Mitigation Plan – FINAL

Whittier Creek Site – Option D Mitigation Project

Re: NCIRT Review and USACE Approval of the NCDMS Whittier Creek Mitigation Site / Surry Co./ SAW-2017-01503/ NCDMS Project # 100020

SUBJECT: Whittier Creek Mitigation Site - NCIRT Comments during 30-day Mitigation Plan Review

**Figure 13. Project Asset and Credit Map
Whittier Creek Mitigation Project - Opt. D
Surry County, NC**

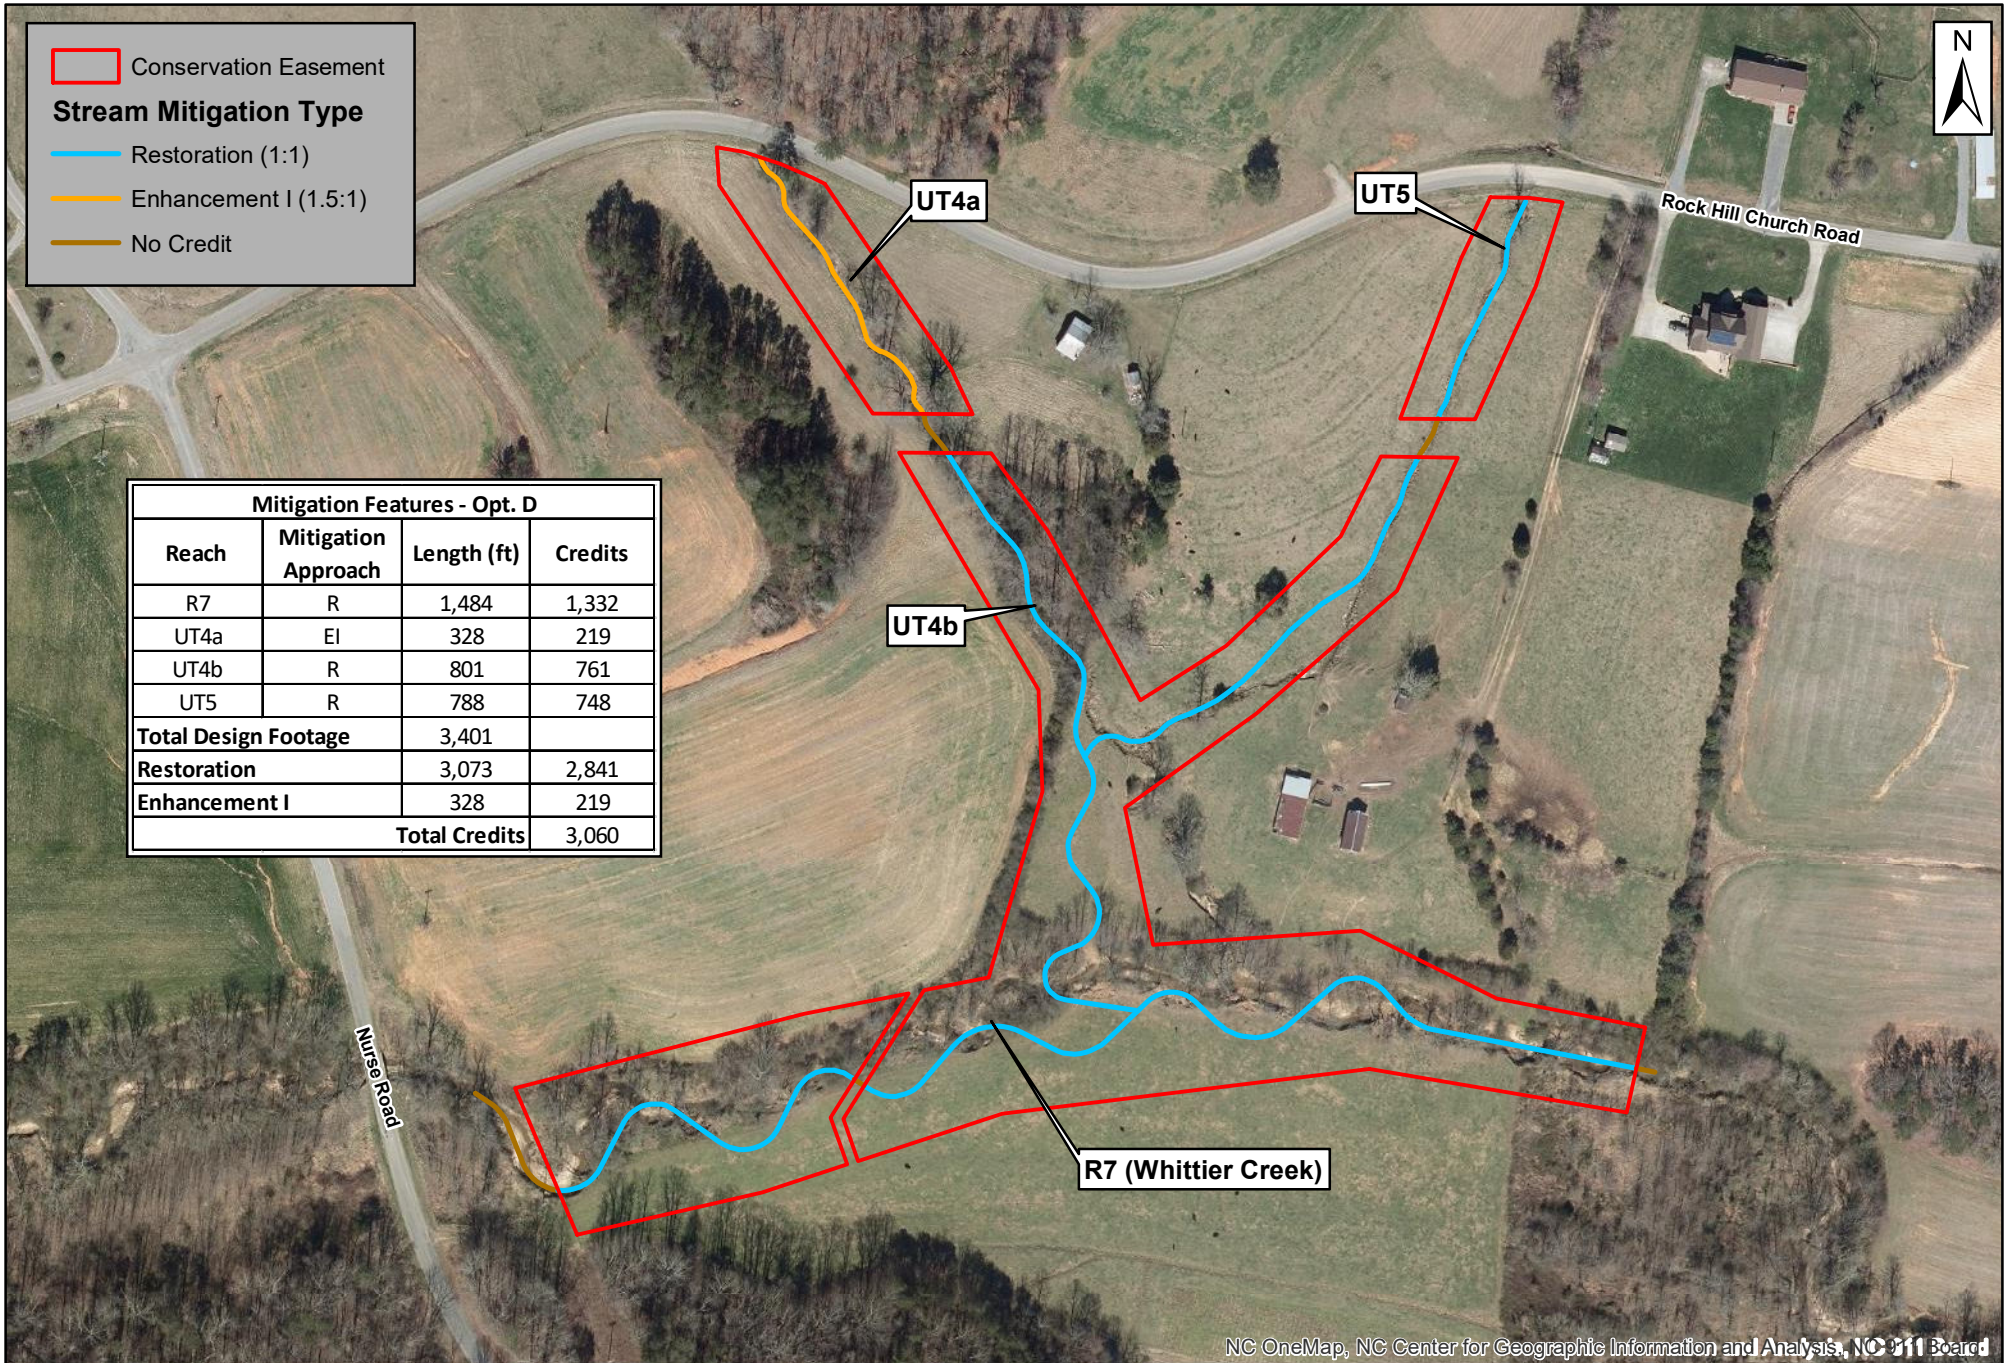
12. Figure 12 - Please show existing onsite wetlands on Figure 12, as well as future monitoring report figures.

Response: The existing wetlands have been added to Figure 12 and will be shown in future monitoring report figures.

OUTLET PROTECTION

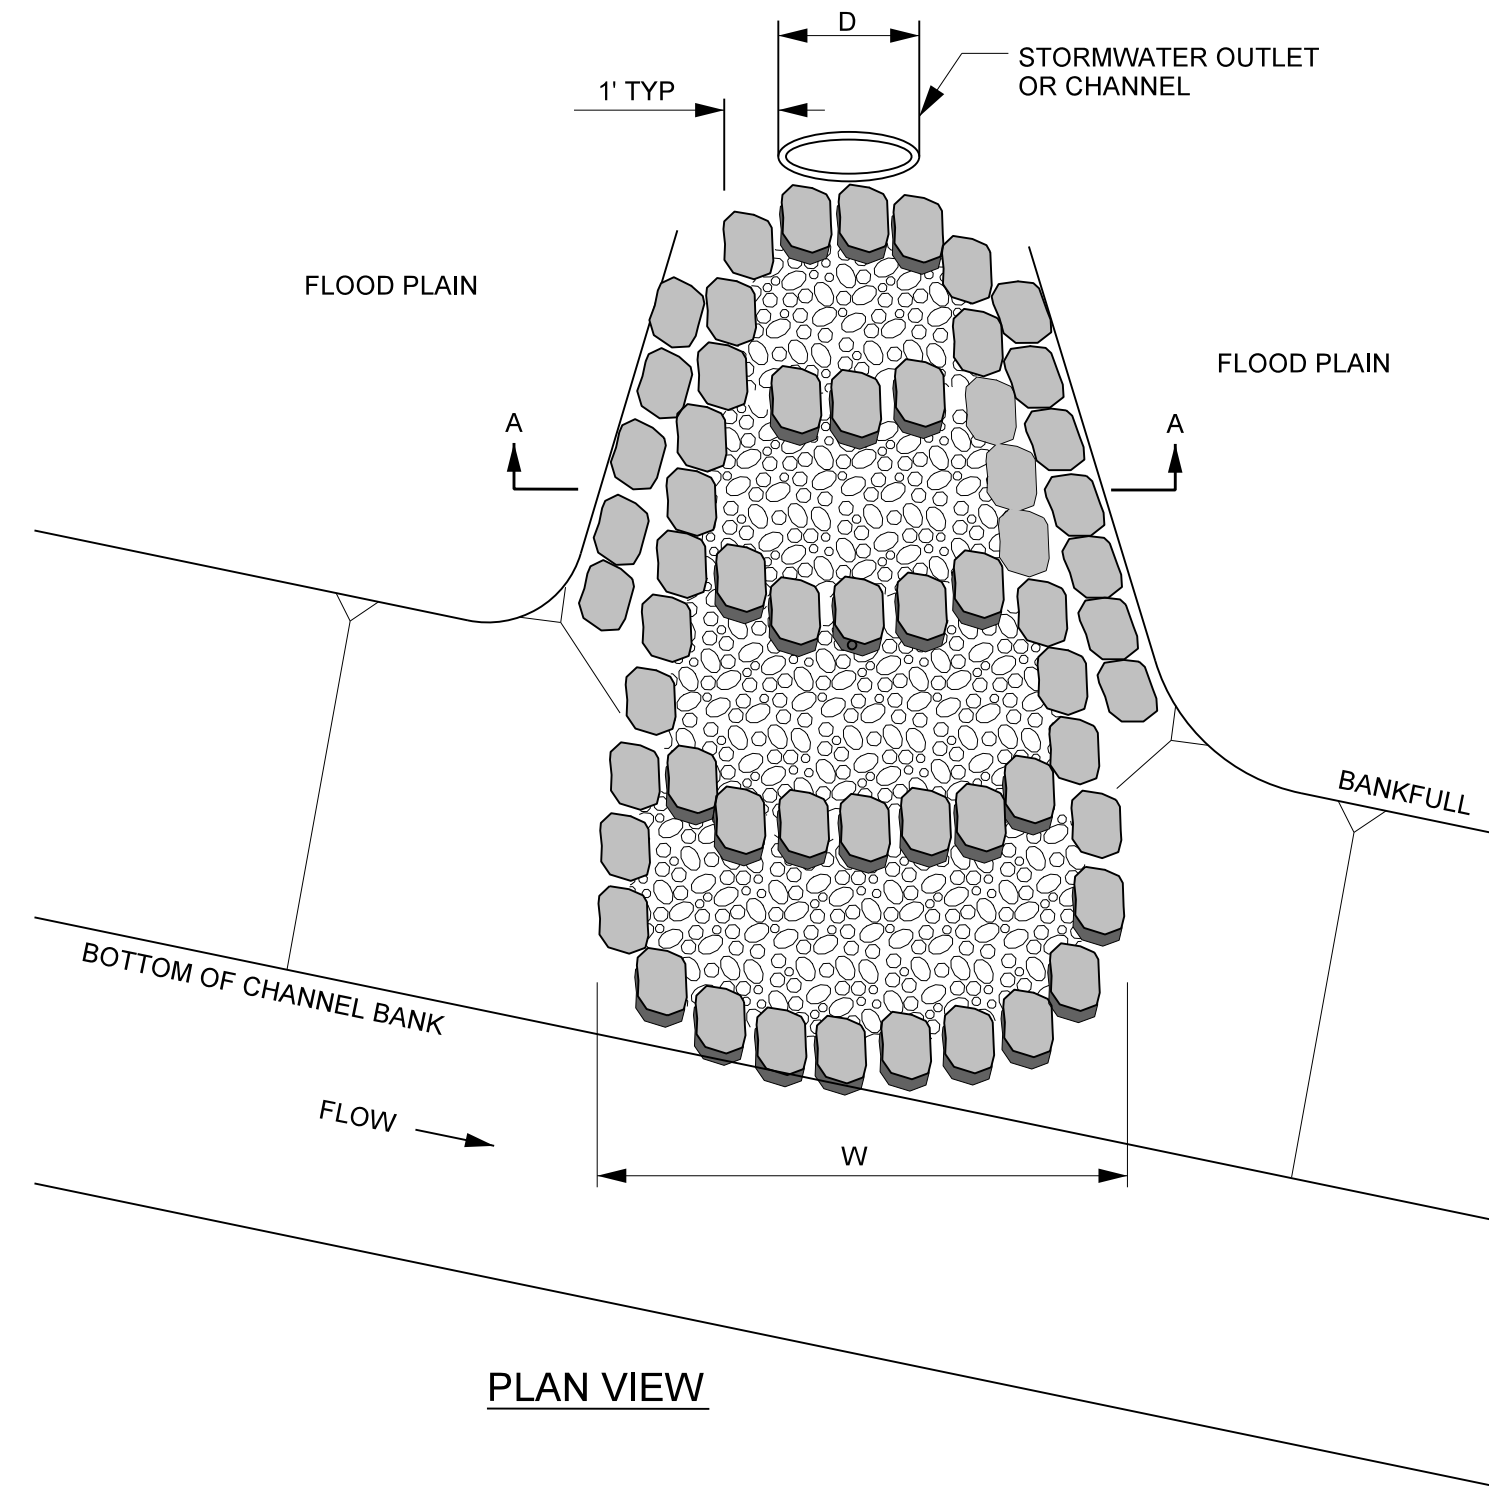
14. Sheet 2A – Is the outlet protection detail being proposed for this project?

Response: There is an outlet protection structure located on lower Reach R7 at Station 23+00 at a point of concentrated runoff from the adjacent field.

CHANNEL PLUG

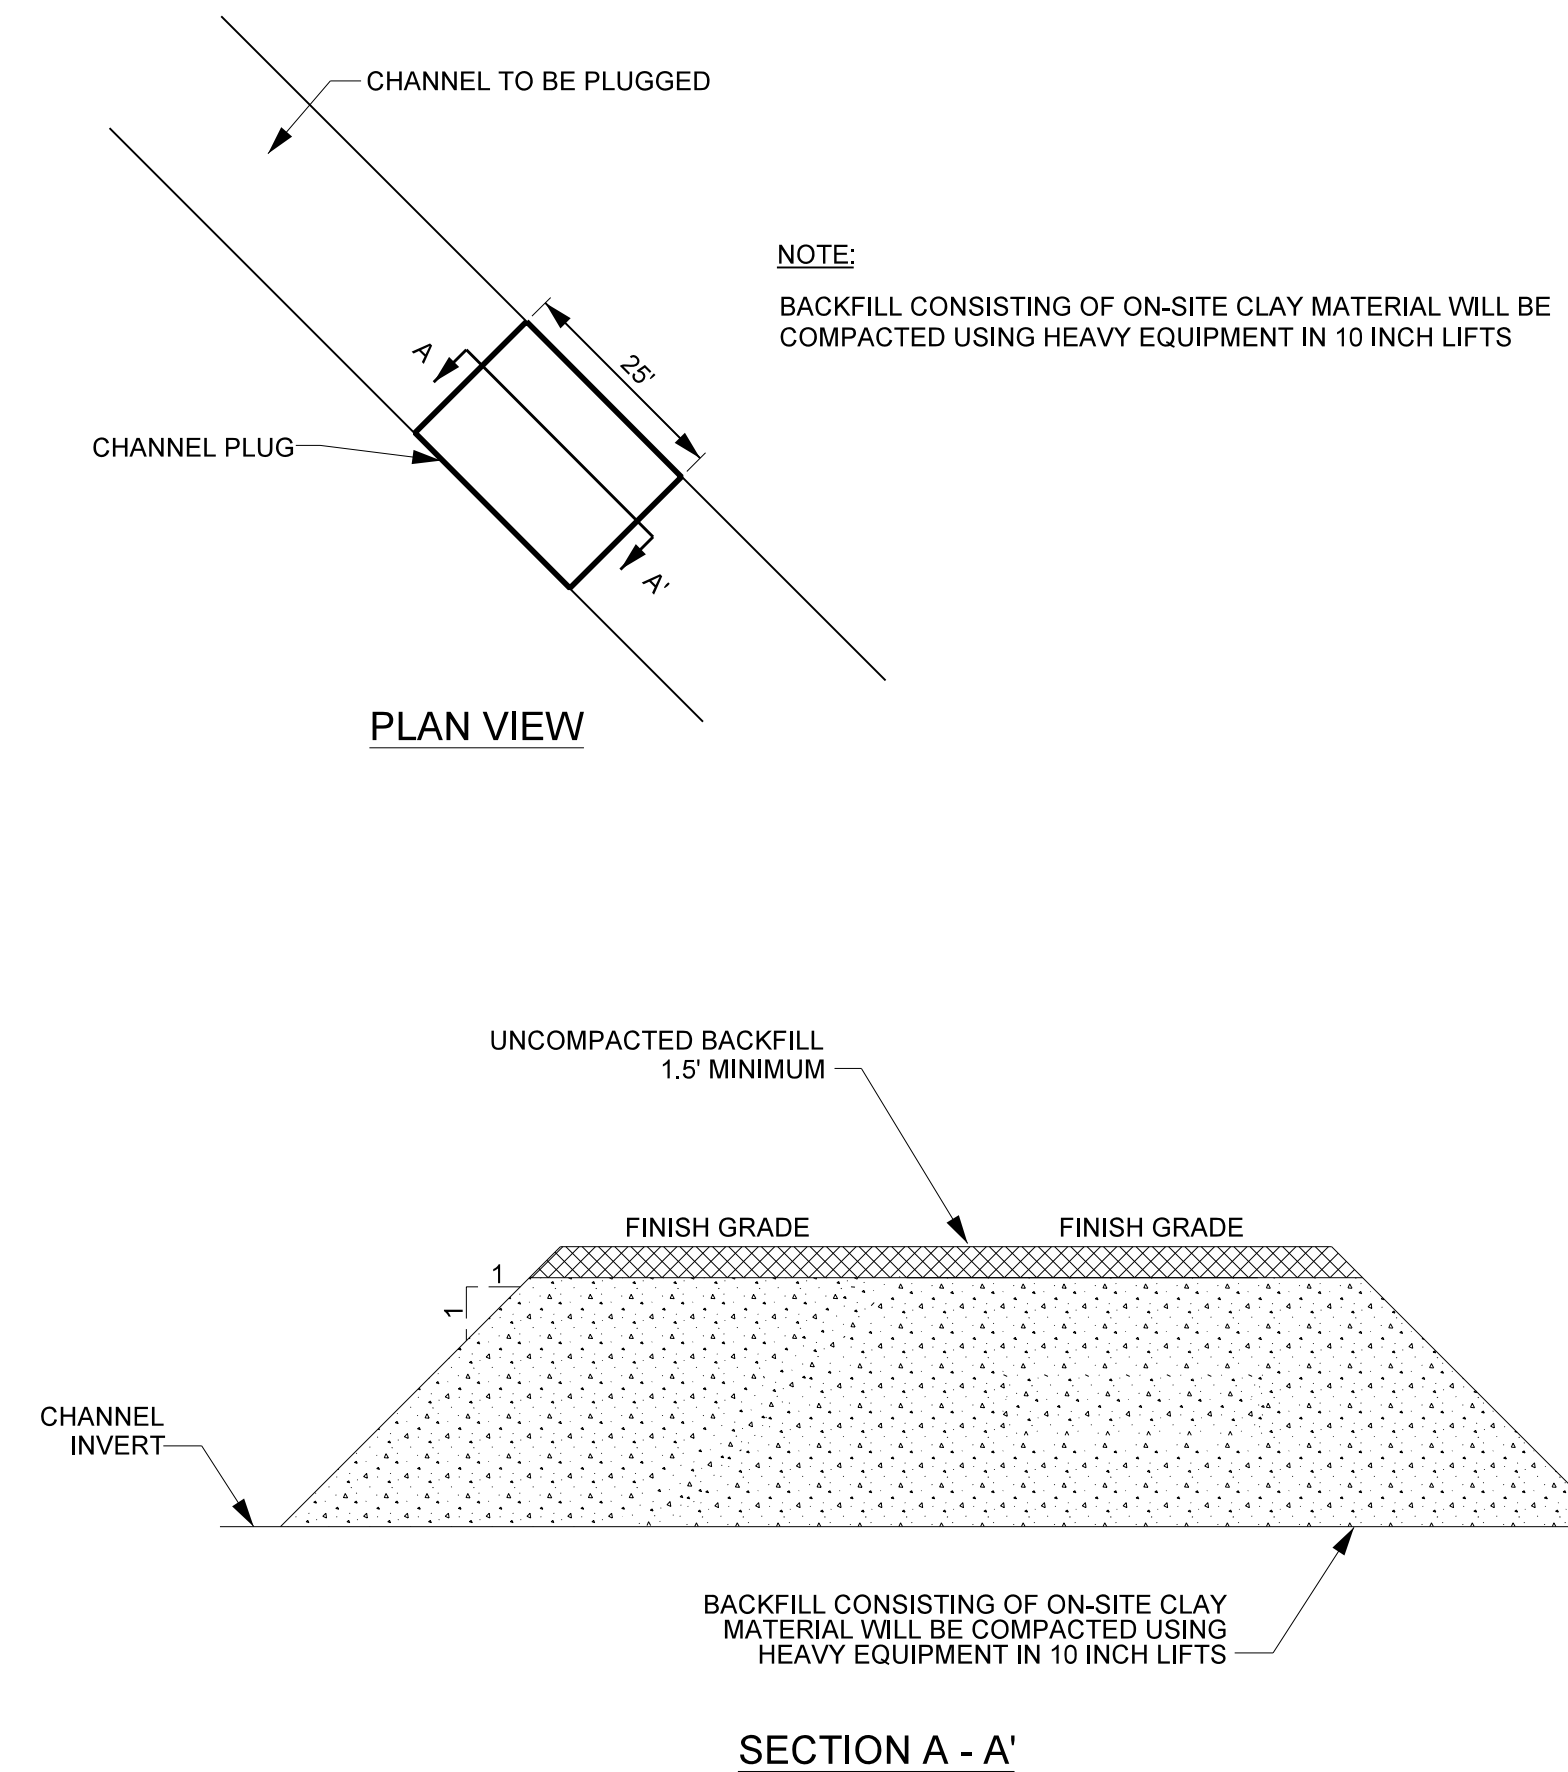
- a. DWR requests plugs be a minimum of 50 feet wide.
 - b. Please include a channel fill detail. If partial ditch filling is proposed, please include a separate detail and indicate the maximum depth from top of bank to be filled.

Response: The channel plugs are a minimum of 25 ft wide, as that is the width of the channel they are plugging, but are much wider in numerous locations on the project as appropriate. The plugs are located in the old channel at locations where the new alignment departs from the old channel alignment. But to be clear, the entire channel will be filled. Baker is confident that the channel plugs are appropriate as designed.

Response: Partial filling of the old channel is *not* being proposed here. It will be completely filled. A separate channel detail seems unnecessary and wouldn’t show much useful information anyway, but an additional note has been added to the channel plug detail stating that the remainder of the channel will be completely filled. If this question is due to concern that deep pools are the design intention (as has been commented on during recent IRT meetings), that is not the case here.
